SOUTH CAROLINA DEPARTMENT OF HEALTH AND ENVIRONMENTAL CONTROL
COMMENTS ON CORRECTIVE MEASURE REPORT FOR COMBINED SOLID WASTE
MANAGEMENT UNIT 14 (SWMU 14) CNC CHARLESTON SC

RE: Comments
CMS Work Plan / IM Completion Report, Combined SWMU 14, Zone H
Charleston Naval Complex (CNC)
SC0 170 022 560

ENGINEERING COMMENTS
Prepared by Jerry Stamps
Charleston Naval Complex (CNC)
June 20, 2002

SPORTENVDETHASN 1899 North Hobson Ave. North Charleston, SC 29405-2108 Ph. (803) 743-6777	
Figure 4 SWMU 14 Confirmation Sample Location/Results Charleston Naval Base Charleston, SC	
DWG DATE: 4/13/98	DWG NAME: 14FIG4

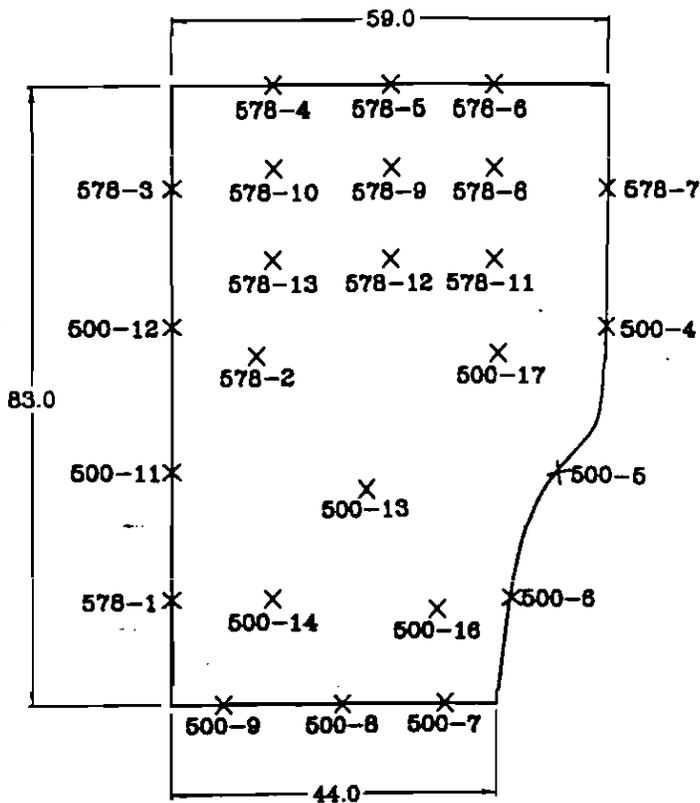
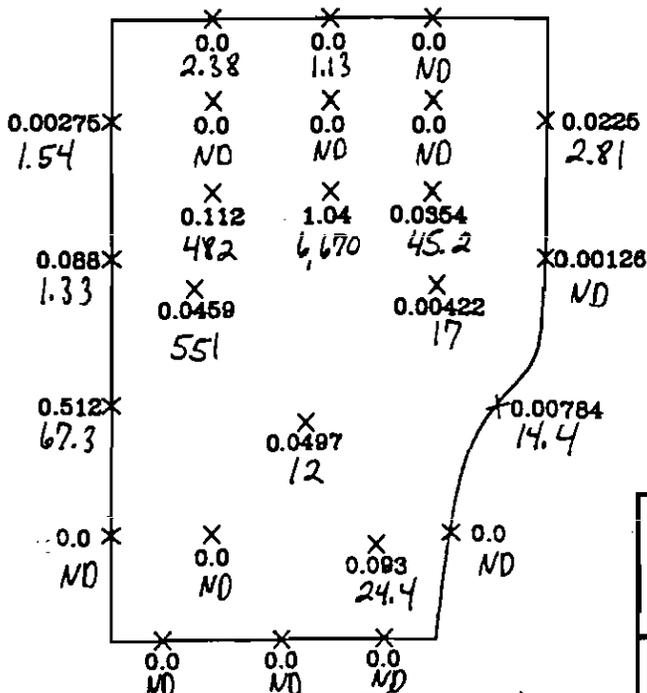
- It appears as though Figure 4 presented in this report is supposed to represent contaminant levels that were left in place after the completion of the soil excavation. If so, then contaminants were left in place in the subsurface soils, which substantially exceed their corresponding generic SSLs. The Department is concerned that these concentrations may serve as a source of continuing groundwater contamination. CH2M-Jones must demonstrate that these contaminant levels are not of concern. Please see the attached figures for the distribution of various contaminants.

TCE

SSL = 3 ppb (DAF = 1)

Figure 4
SWMU 14
Confirmation Sample Location/Results
Charleston Naval Base
Charleston, SC

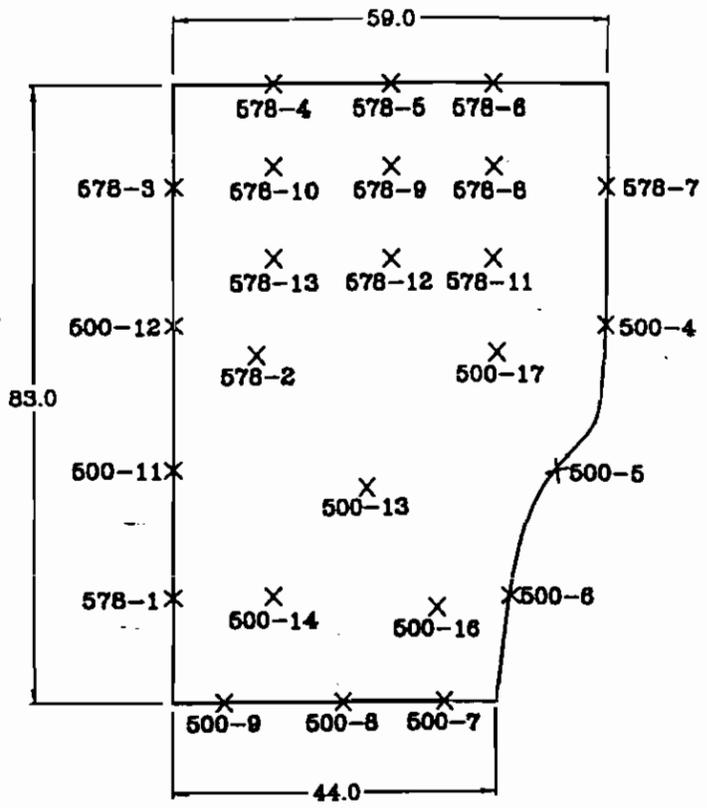
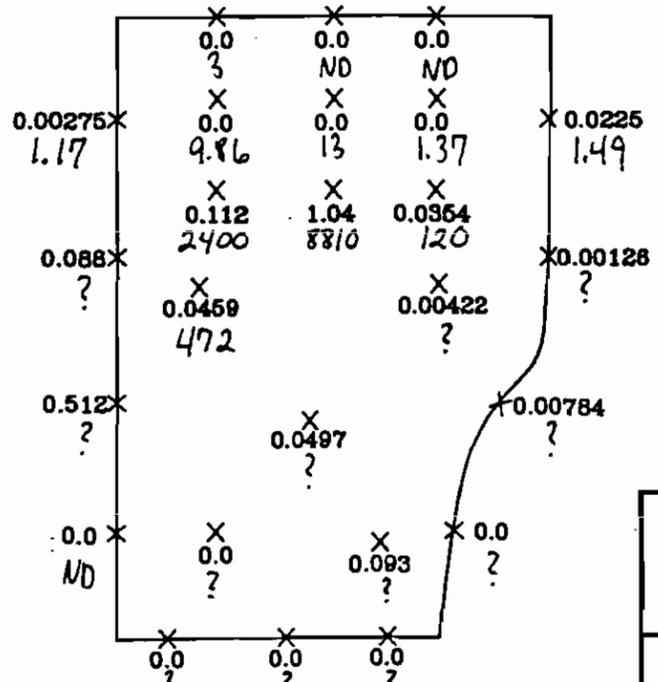
CIS-1,2-OCE

SSL = 20 ppb (DAF=1)

? = analysis appears to have been for trans-1,2-OCE only

SPORTENVDETHASN 1899 North Hobson Ave. North Charleston, SC 29405-2108 Ph. (803) 743-6777	
Figure 4 SWMU 14 Confirmation Sample Location/Results Charleston Naval Base Charleston, SC	
DWG DATE: 4/13/98	DWG NAME: 14FIG4

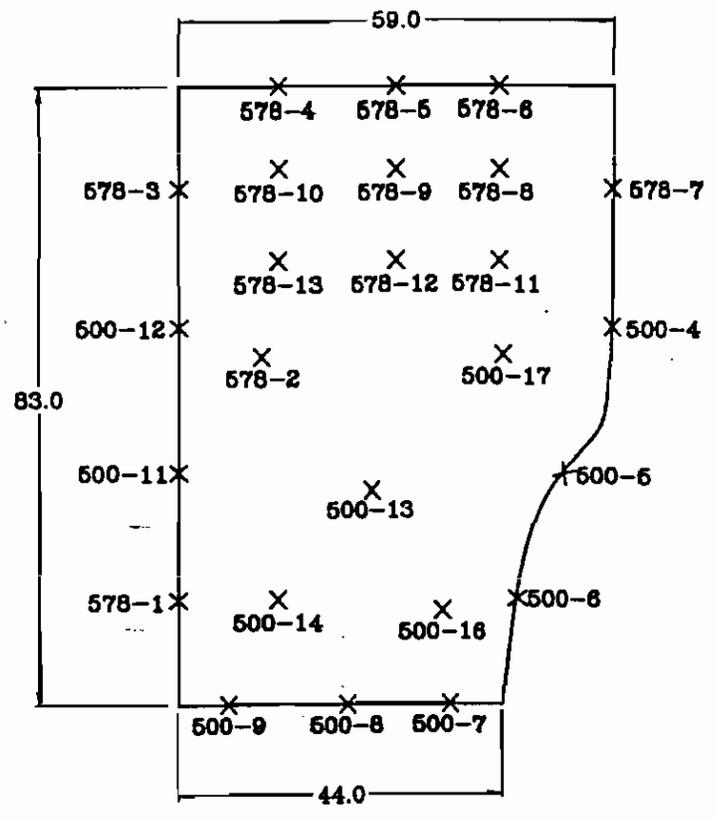
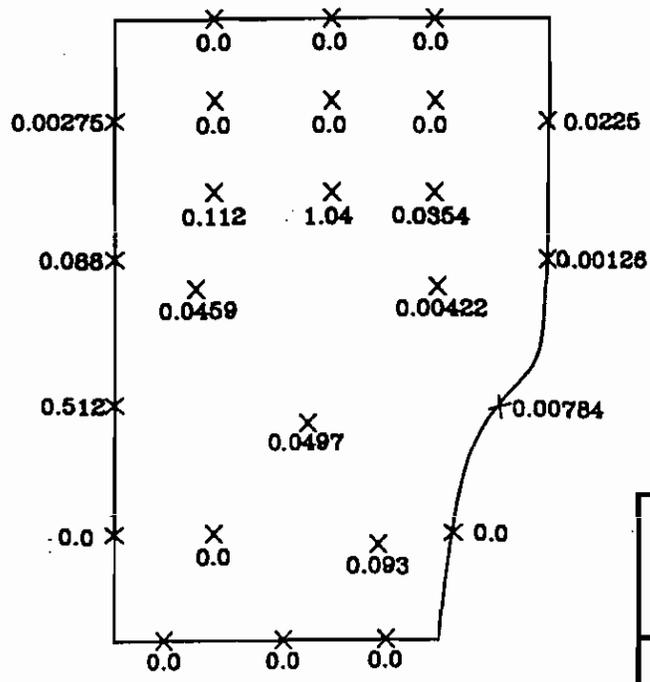
This section states that the confirmation samples collected from the DANC removal did not show contaminants at concentrations exceeding RBCs or SSLs. However, it is not clear as to what DAF was used in the SSL comparison. Furthermore, it appears from Figure 4 of the Interim Measure report that TCA remains in the soil well above its corresponding SSL of 0.2 ppb (DAF = 1). This reviewer developed figures similar to this for other chlorinated compounds to determine the distribution of the contamination that remains after the excavation was complete. Please see the attached figures. The Navy must demonstrate that the remaining contamination is not a threat to the groundwater quality in this area.

1,1,2,2-TCA

SSL = 0.2 ppb (DAF=1)
= 0.0002 ppm

Figure 4
SWMU 14
Confirmation Sample Location/Results
Charleston Naval Base
Charleston, SC

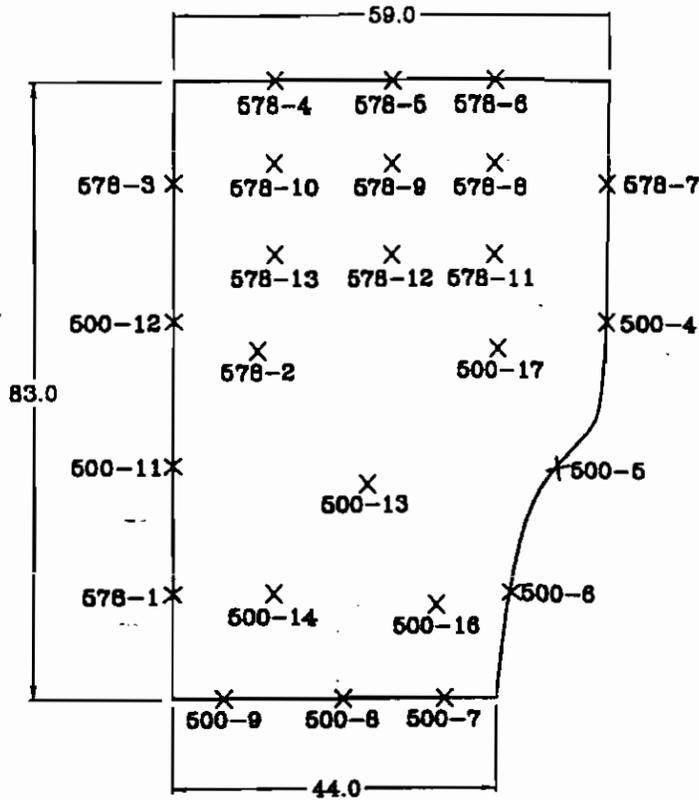
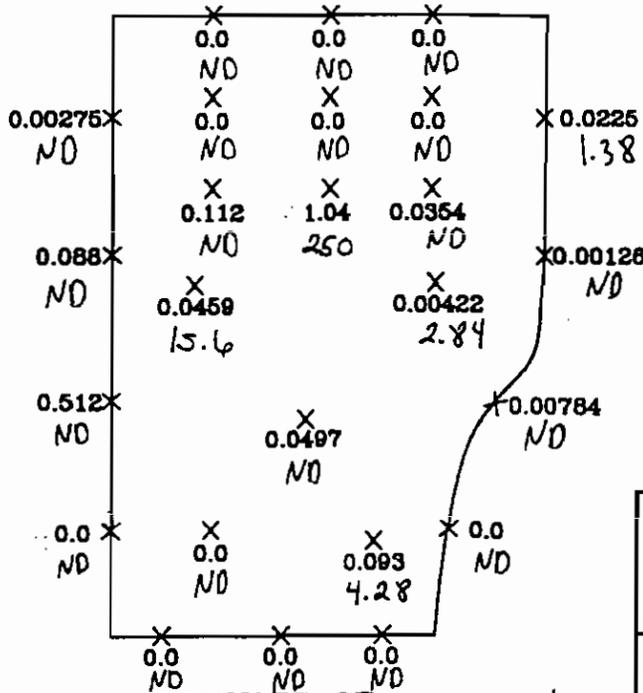
SSL = 3 ppb (DAF=1)
